# TRAFFIC MANAGEMENT SUB-COMMITTEE

5. RESULTS OF STATUTORY CONSULTATION OBJECTIONS-FUNDED BY LOCAL COMMUNITY INFRASTRUCTURE LEVY (CIL) CONTRIBUTIONS APPENDIX 1.2 - NORTHUMBERLAND AVENUE 3 - 8

## Appendix 1.2, Reading Girl School (Northumberland Avenue) - Feedback to Statutory Consultations

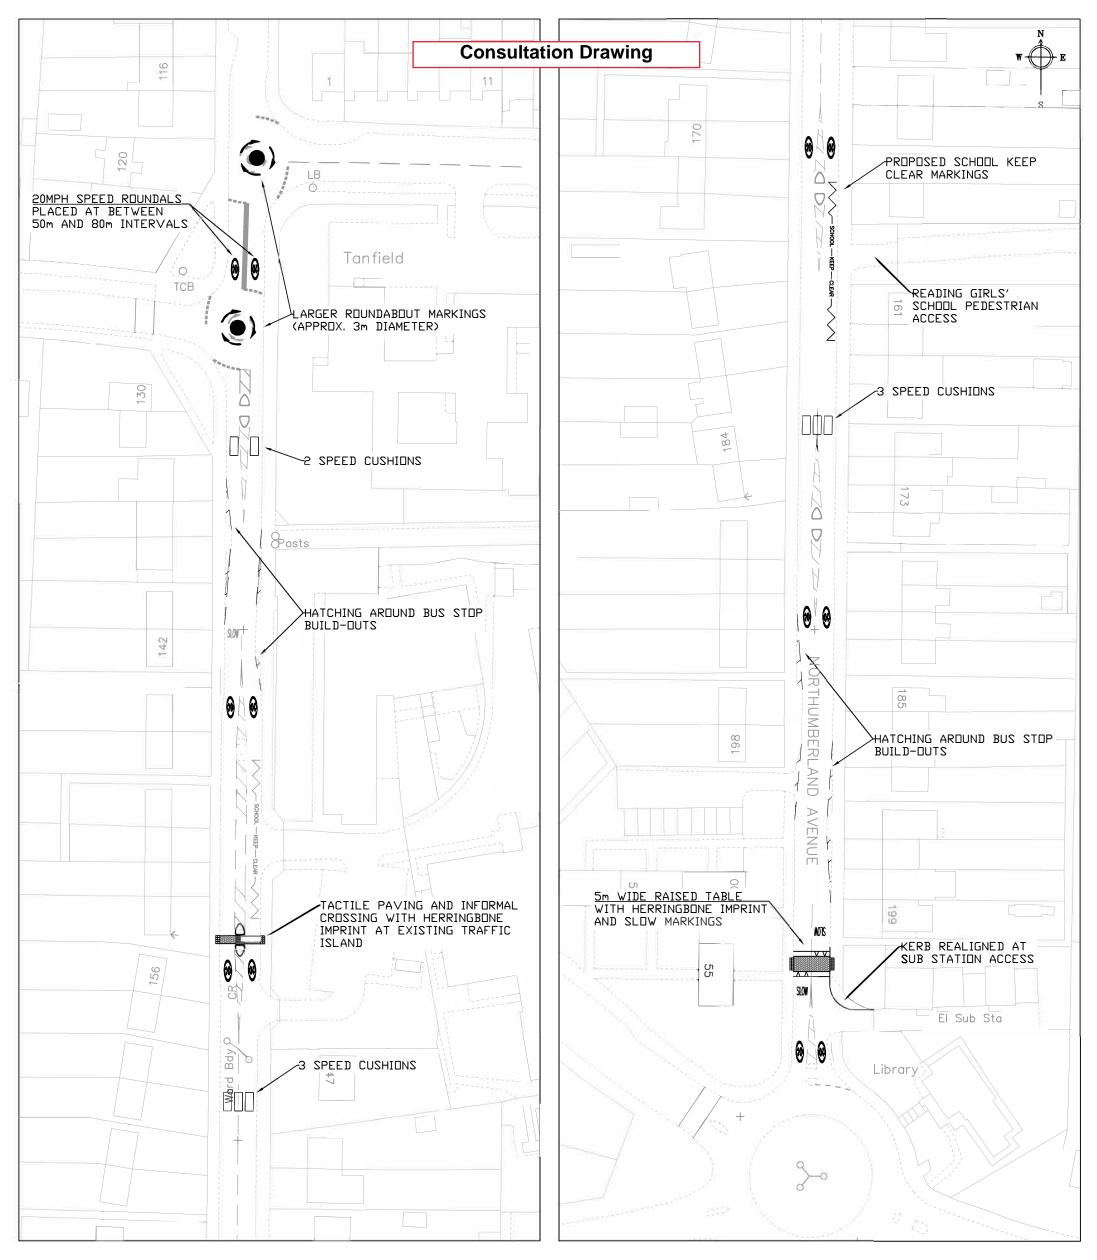
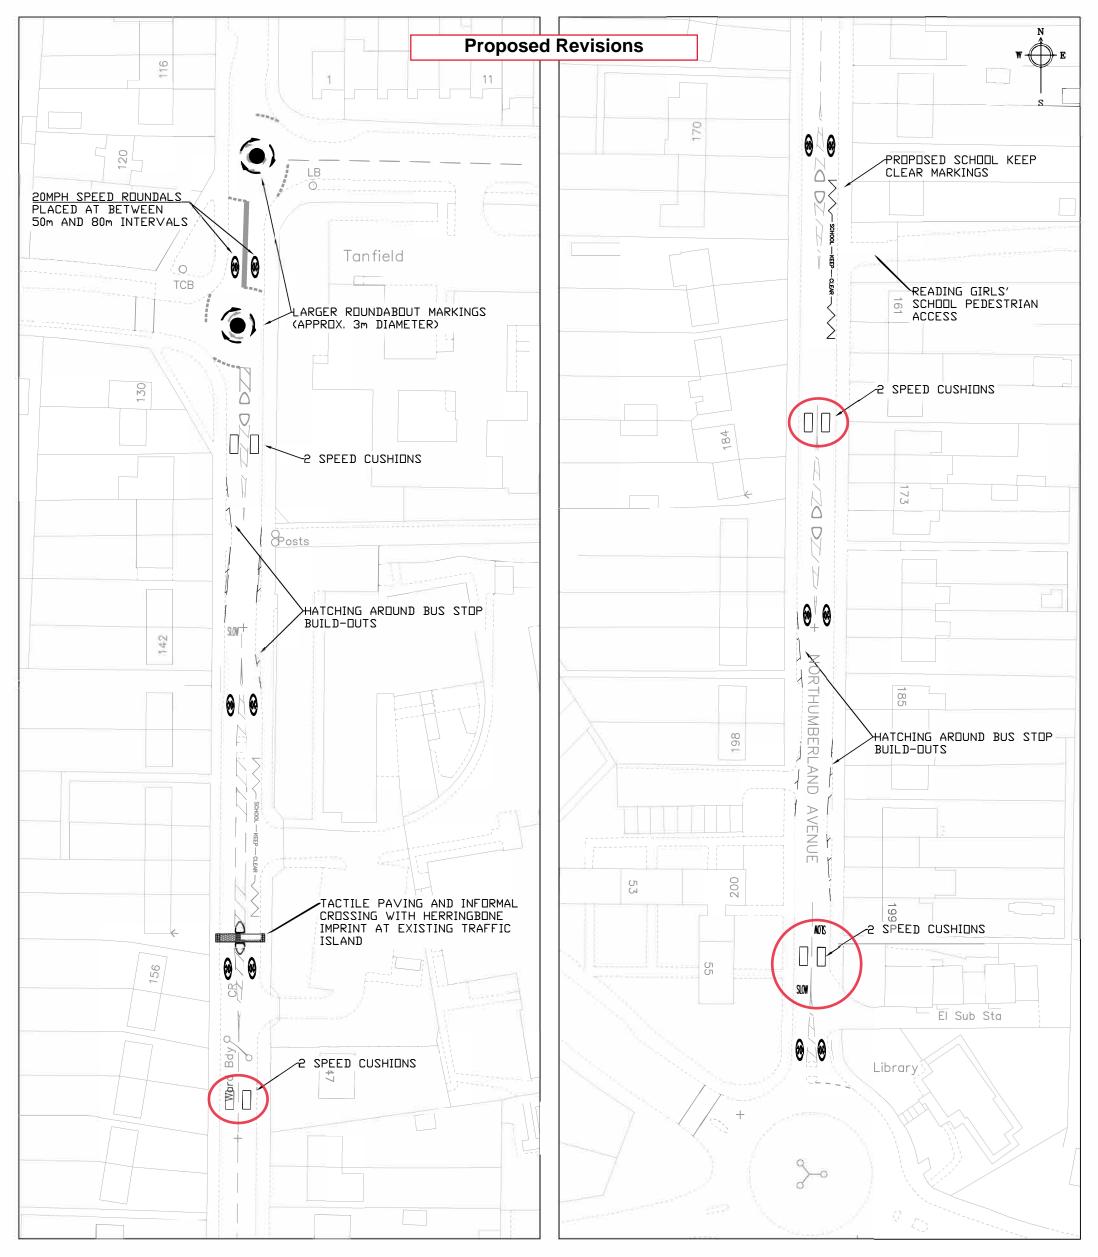
Summary	Feedback received				
	Summary of responses: Objections - 3, Support - 1				
1) Objection	I live at [REMOVED] Northumberland Avenue. May I comment on the proposal for a 20mph speed limit. Whilst I appreciate the reduction in speed, I have reservations over the siting of the speed table 25mtr from Long Barn Lane junction.				
	Over the course of many years we have suffered vibrations (on record) within the house especially when the road was in poor condition, thankfully we have now lived with a relative peaceful life since the road was resurfaced. However, from my knowledge and experience dealing with road speed cushions and tables elsewhere, there will be an issue of vibration when buses or heavy vehicles exit the table and damage the existing road surface at the departure landing zone. I consequently believe the table is too close to my house to cause vibration. In addition there is a service manhole which has only recently been renewed due to noise and disturbance. Therefore the speed table does need to have sufficient gap between it and the service manhole covers.

A repositioning or siting of the table a few metres southwards of the manhole covers may alleviate any chance of causing disturbance to both the manhole covers and my house.

• We would request that the proposed Raised Table is replaced by 2 split cushions. The Raised Table does not appear long enough for a full-size bus to fully ascend the table before leaving it.

• We would recommend the 2 x 3 split cushion to be replaced by 2 x 2 split cushions.

This change would continue to have the desired traffic calming effect but will allow buses to straddle the cushions and pass over them, without impacting the safety of passengers on the vehicle, particularly those who may not be seated. The impact of passing over a speed cushion are significantly magnified when compared to the occupants of a private car especially when taking into account that bus passengers are not required to wear seat belts and may be standing. Meanwhile our drivers are exposed to the impact on as repeated basis, even at low speeds.

3) Objection	Some years ago, in the Shinfield Road consultation, the council revealed that speed cushions are unnecessary in 20 mph zones. In other roads in the area, such as Whitley Wood Lane, cars often park adjacent to the speed cushions, with one wheel in the gap between the kerb and cushion, and the other on the pavement. The result is that the buses have to drive over the cushions, leading to a rough ride and bus shaking. Therefore I favour the extension to the 20 mph zone, but oppose the speed cushions.

Officer Comment: Officers acknowledge concerns raised by the local bus company and appreciate Northumberland Avenue is a busy bus route with high frequency of bus services in both directions. To address the concerns, officers recommend that the Sub-Committee considers a modified proposal that replaces the sets of three cushions and the raised table with sets of two speed cushions. The attached drawings show the consulted and the modified proposals.
	The recommended modified proposal is still anticipated to provide effective features that will help achieve compliance with the 20mph restriction, however, it should be noted that they will result in the loss of an intended uncontrolled pedestrian crossing.
4) Support	improved driver behaviour reduction in severity of injuries safer generally for all pedestrians less fuel pollution
